PITT STREET NORTH
OVER STATION
DEVELOPMENT

SUBMISSIONS REPORT

Figure 9 – Three contemplated construction scenarios in relation to construction of the integrated station development

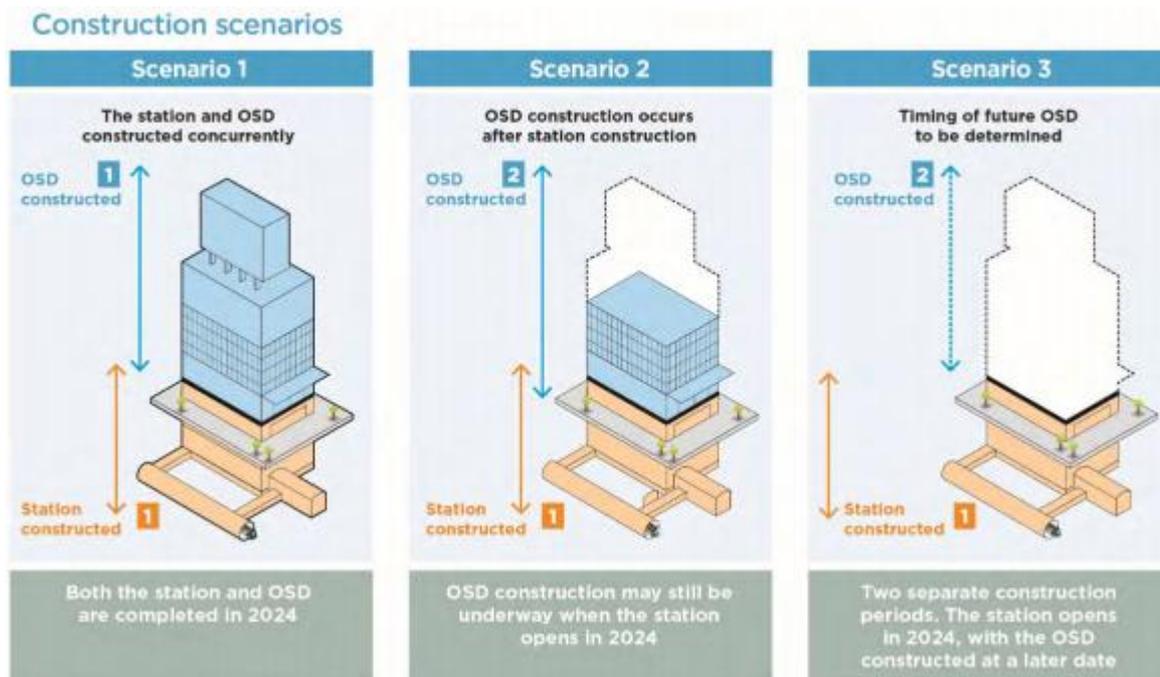
Of the above, Council's issue pertains to Scenario's 2 and 3. Council asserts that by contemplating these scenarios, Sydney Metro is confirming that there would be an adequate degree of flexibility in the program to allow for the undertaking of a design competition in accordance with the *City of Sydney Competitive Design Policy*.

Figure 17 – Elevation demonstrating the scale of the building to the Galleries, located to the west of the site

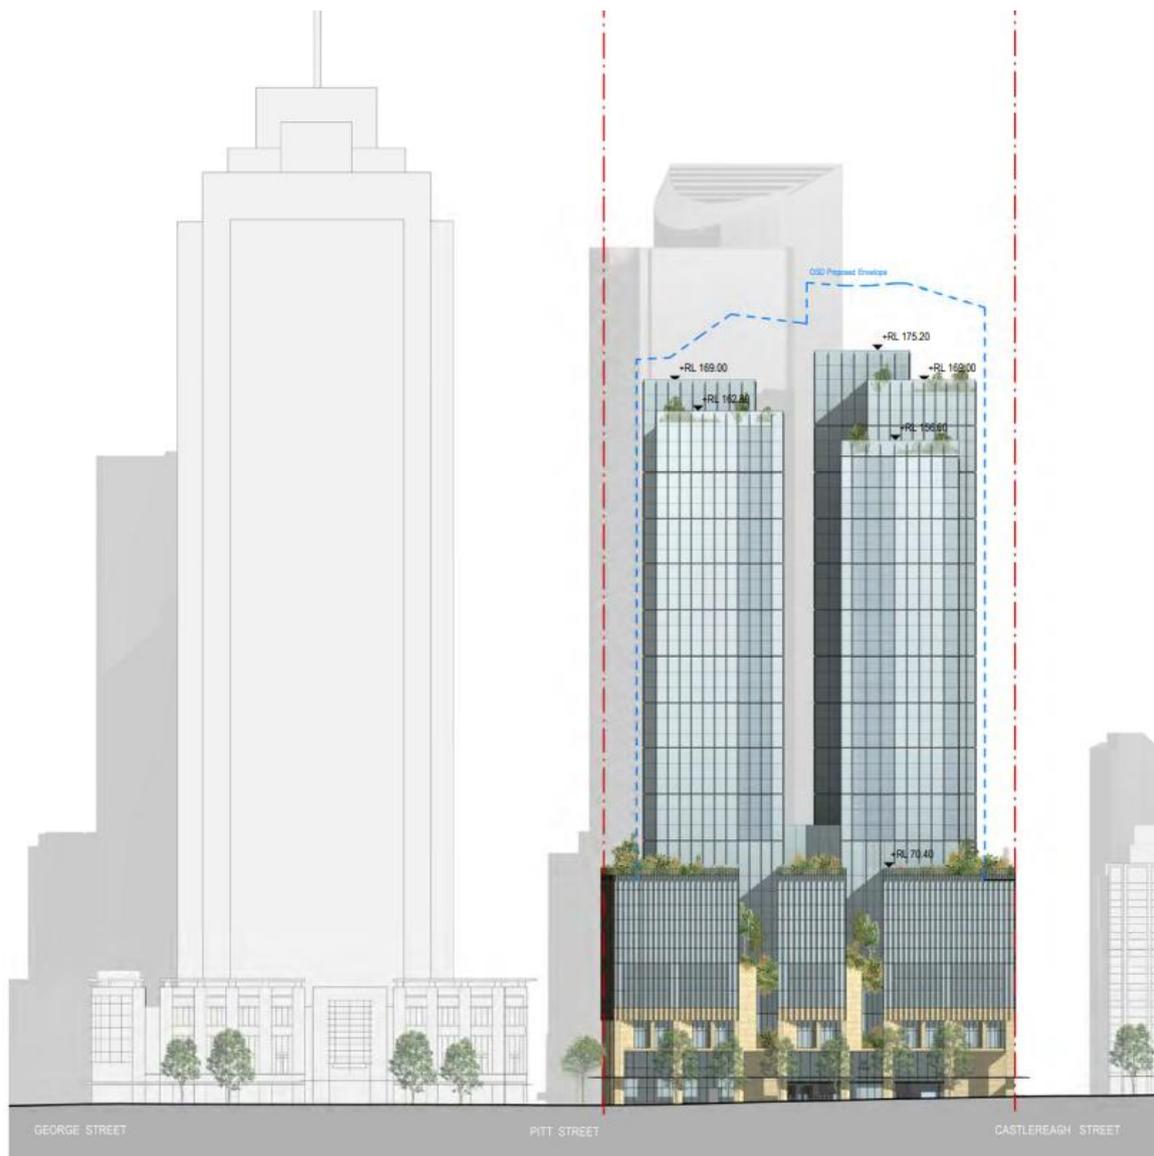
DPE has requested that further justification be provided on the scale of the Galleries Victoria podium and streetscape along Park Street. Specific note is made of the impact from the development on views to and from Sydney Town Hall. As demonstrated at Figure 17, the Galleries features a podium height which is of lower scale than that proposed as part of this application.

Figure 18 – Photograph identifying the site, as viewed from Town Hall steps

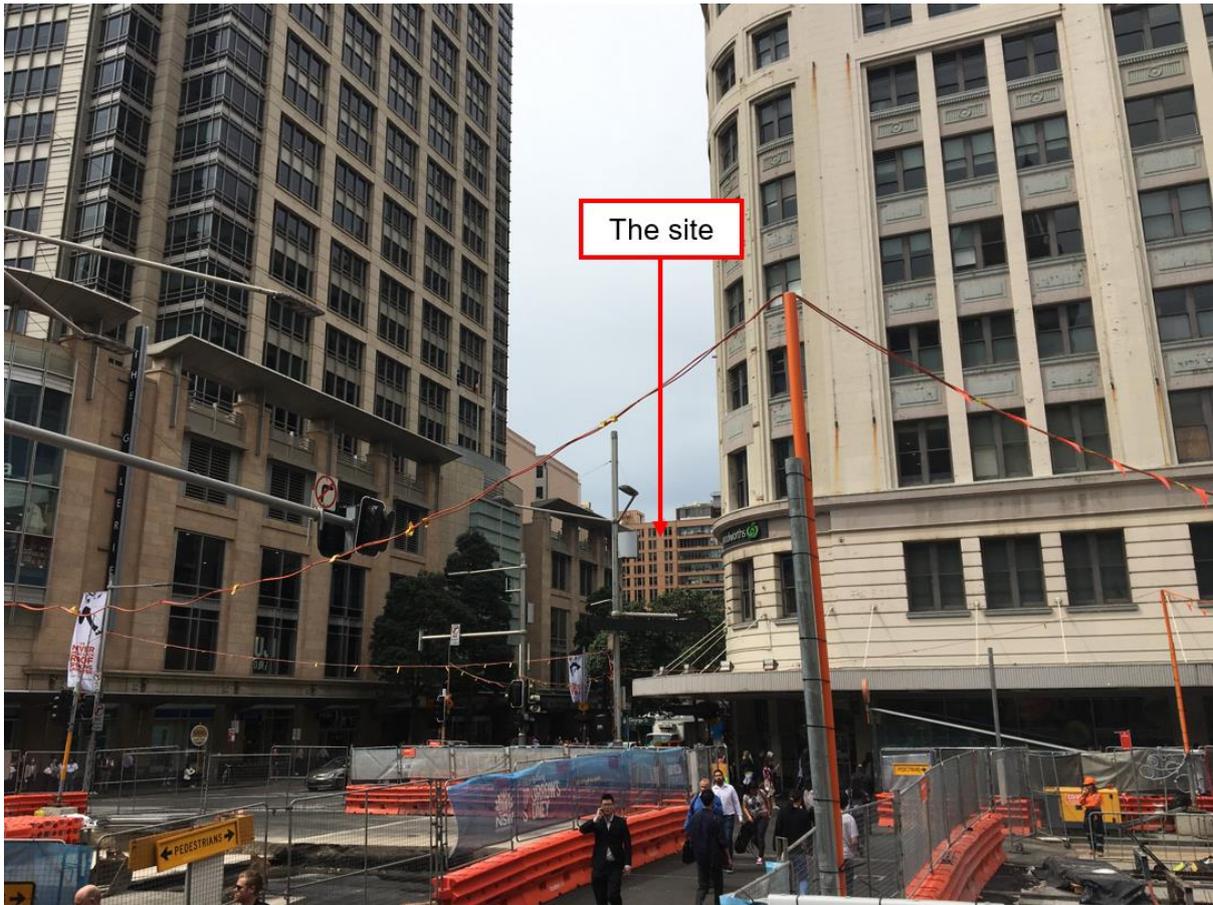
DPE has also requested additional consideration of views of the proposed development to and from Town Hall. The proposed envelope, including the podium height would have minimal, if any impact on views to or from Town Hall.

As demonstrated in Figure 18, the site is currently obscured when viewed from Sydney Town Hall, and the proposed podium (over and above the scale which will be delivered irrespective due to the nature of the CSSI Approval) would have minimal impacts on views to or from Town Hall. In effect, this comprises only the 20 metre section between the top of the CSSI Approval envelope and the proposed maximum street frontage height. Although some bulk would be visible from Town Hall, it would be commensurate with the surrounding CBD character and would not be out of place in the context of surrounding development.

Figure 20 – Demonstration of the OSD envelope in relation to the Hyde Park West 3 Sun Access Plane

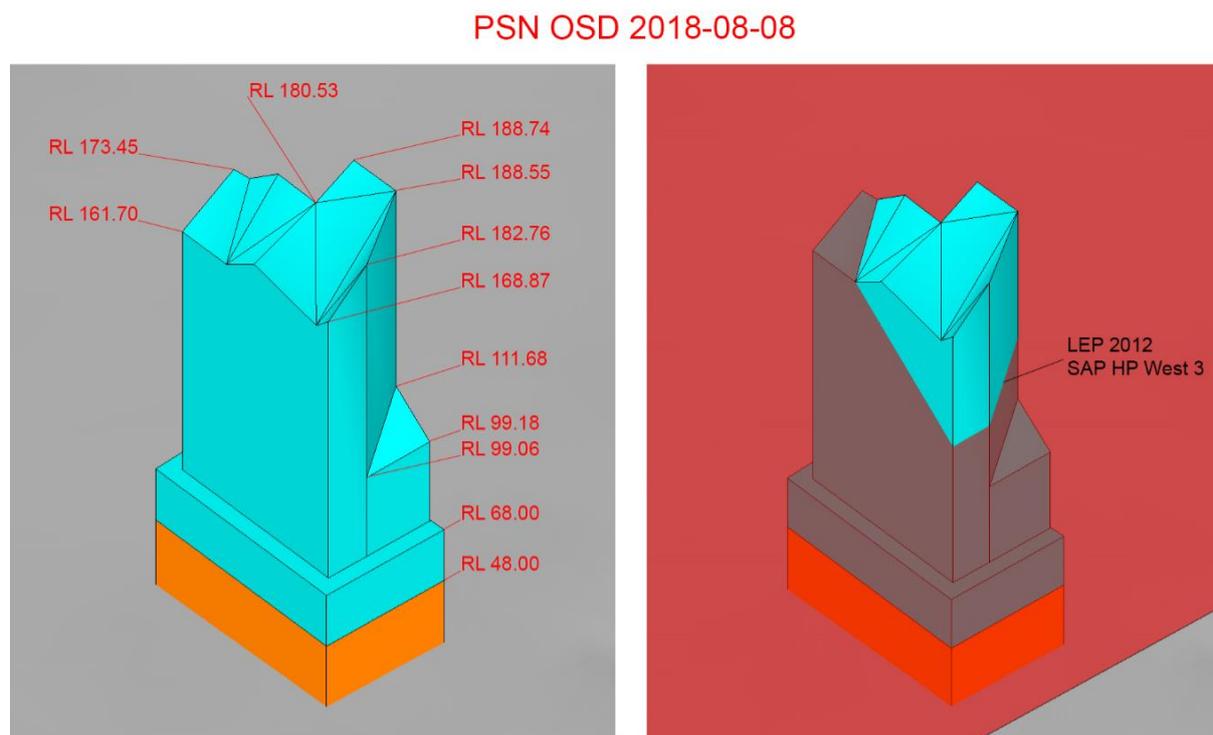
DPE has requested that visual illustrations be submitted which demonstrate the proposal's compliance with the Hyde Park Sun Access Plane. Demonstration of the development's relationship to the Sun Access Plane is provided at Appendix K.

Additionally, a detailed discussion of the proposal's compliance with Clause 6.18 of the SLEP 2012 has been provided at Chapter 9.3 of the originally submitted EIS. As discussed in the EIS, the proposal does not comply with the Hyde Park Sun Access Plane, by virtue of the exceptions to the Hyde Park Sun Access Plane permitted under Clause 6.18 of the SLEP 2012. This has been visually demonstrated at Figure 20 below.
